Totalflow product line

# Technical bulletin 195

## RTD measurement performance specification deviation

Date: **2/25/2013**

#### 4.4. Installing the Cable in a $\mu$ FLO<sup>G4</sup>

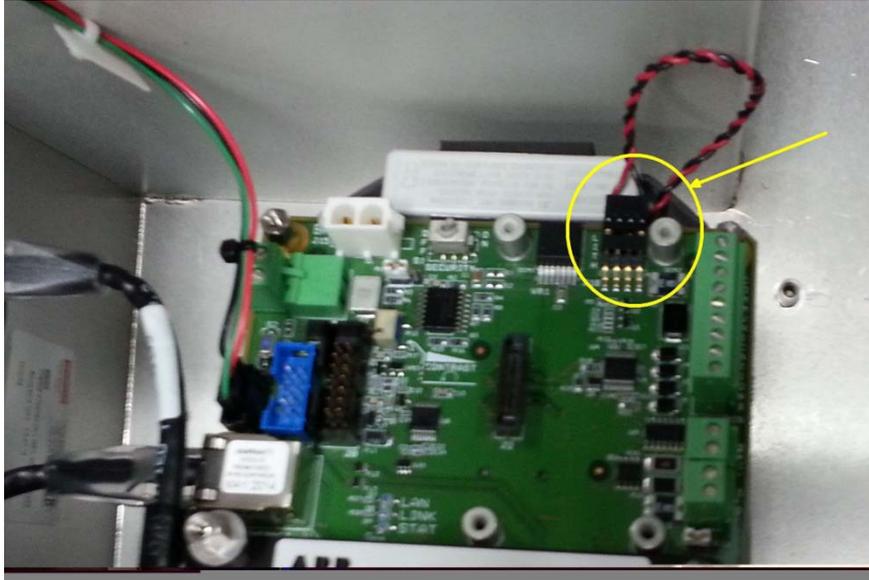
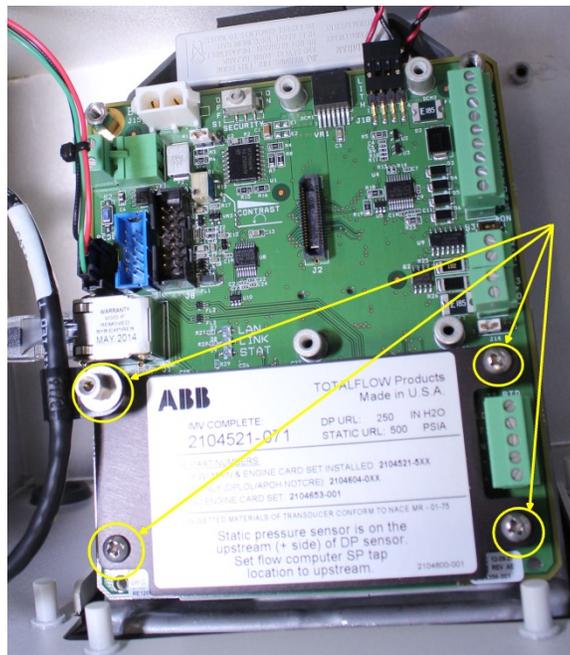
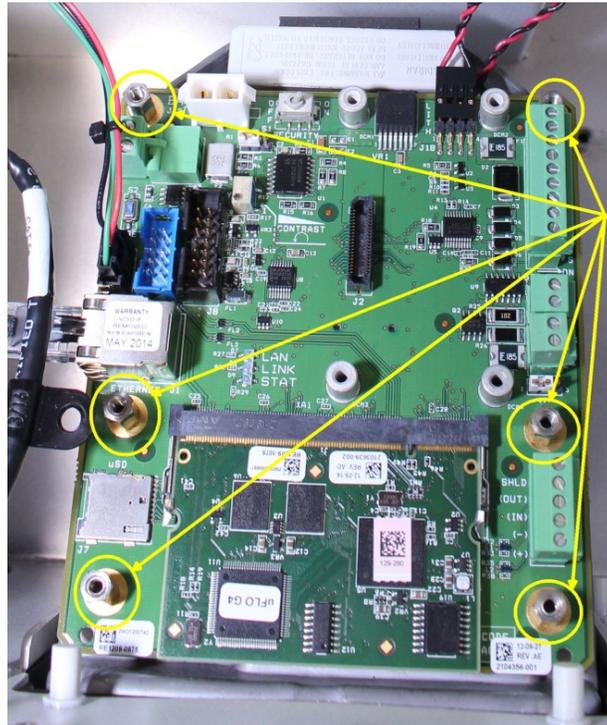
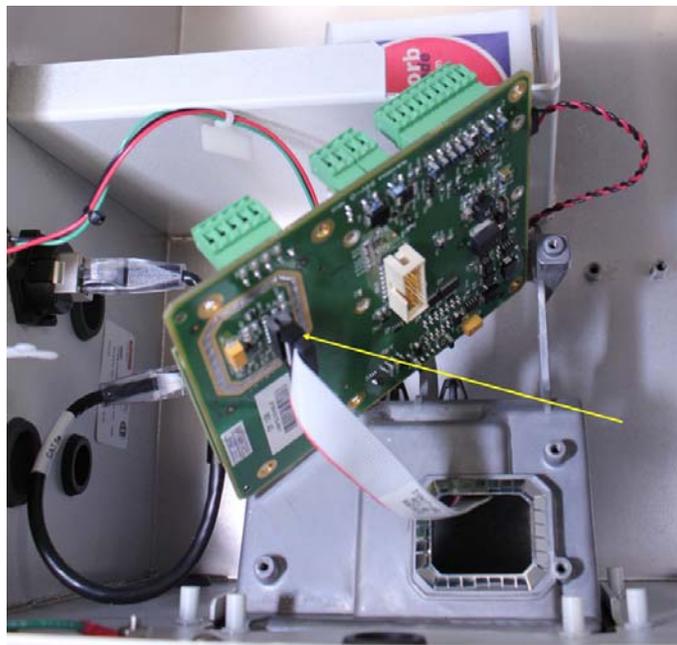
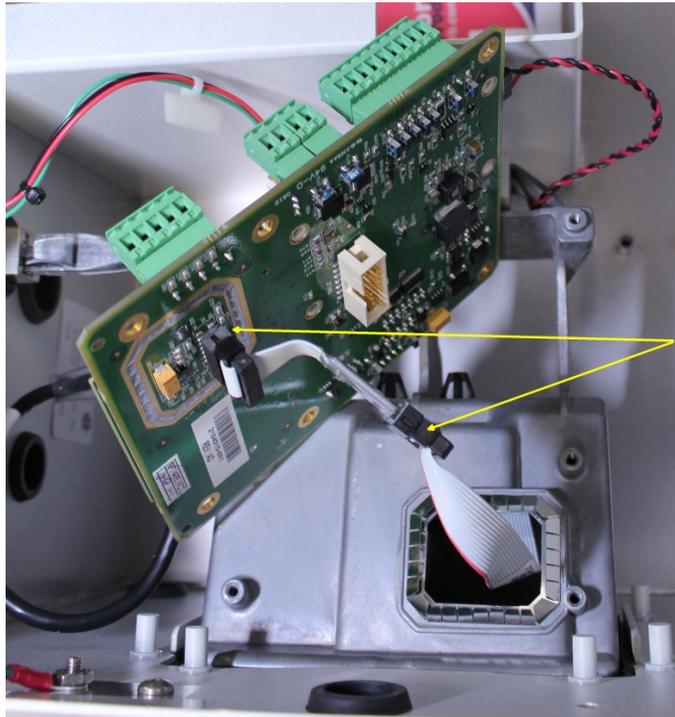
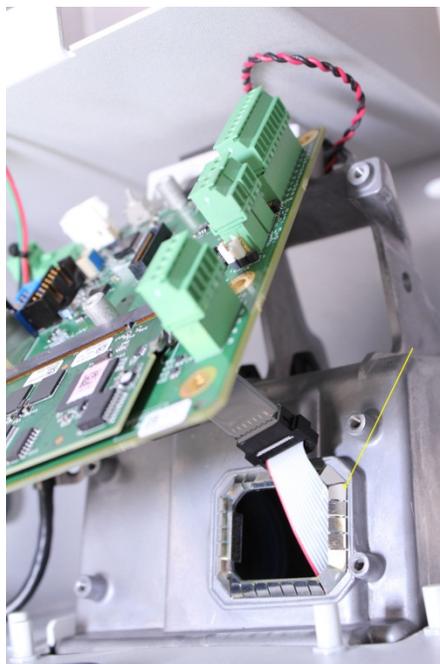
5. Attach the new cable between the existing sensor cable and the electronics board.

6. Tuck the cable into the hole. Make sure the EMI gasket is back in place within the ridges around the hole.

#### 4.5. Installing the Cable in a 6200/6201EX<sup>G4</sup>

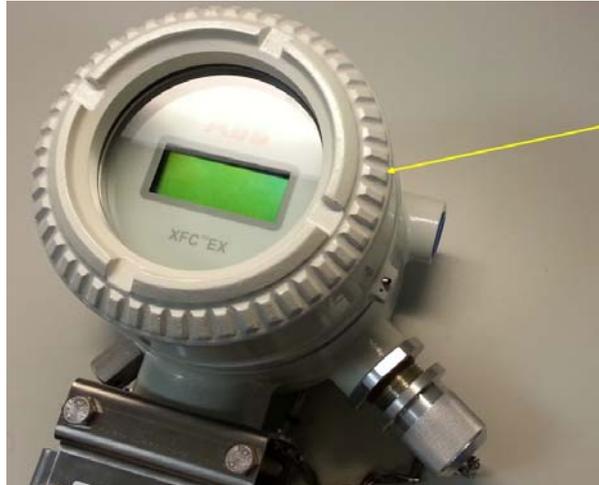
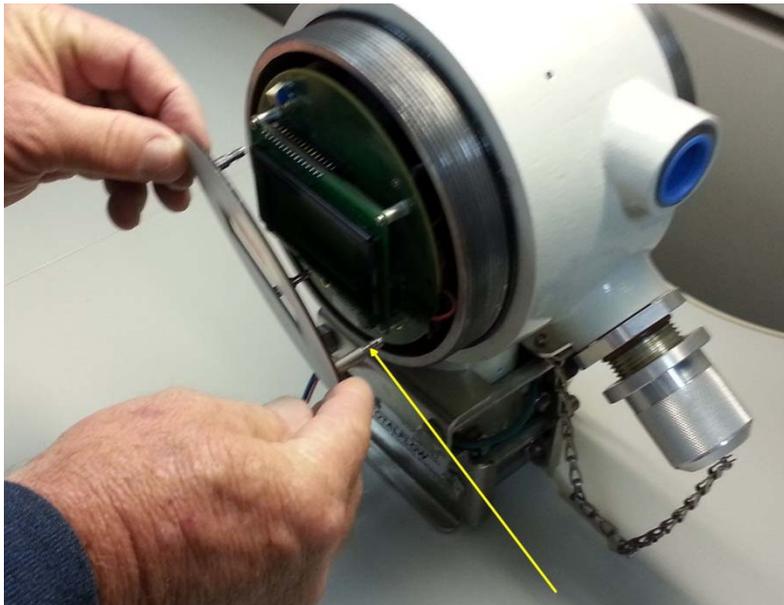
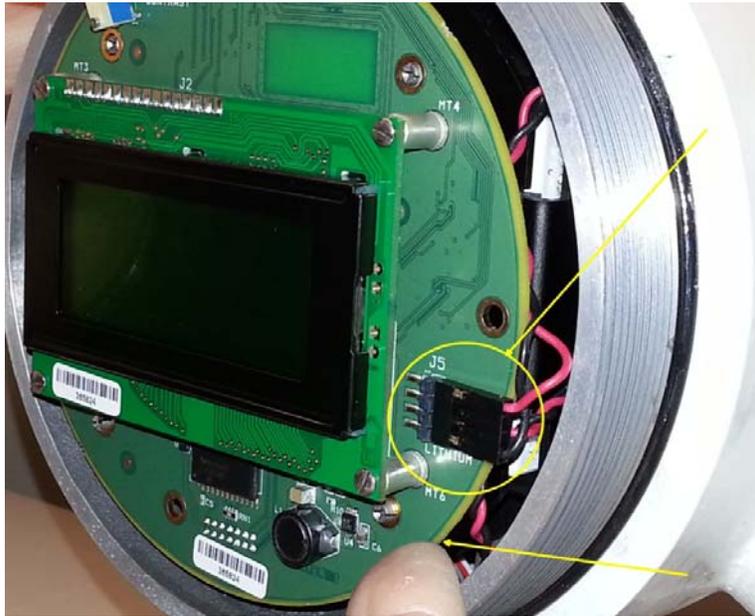
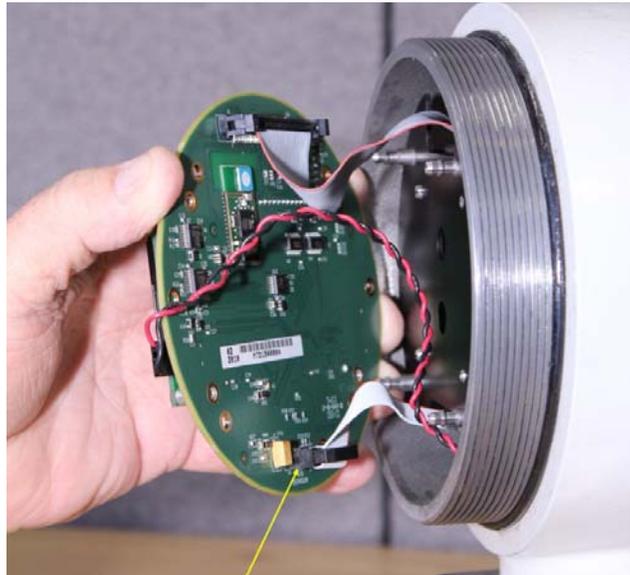
5. Insert the new cable between the existing sensor cable and the electronics board.
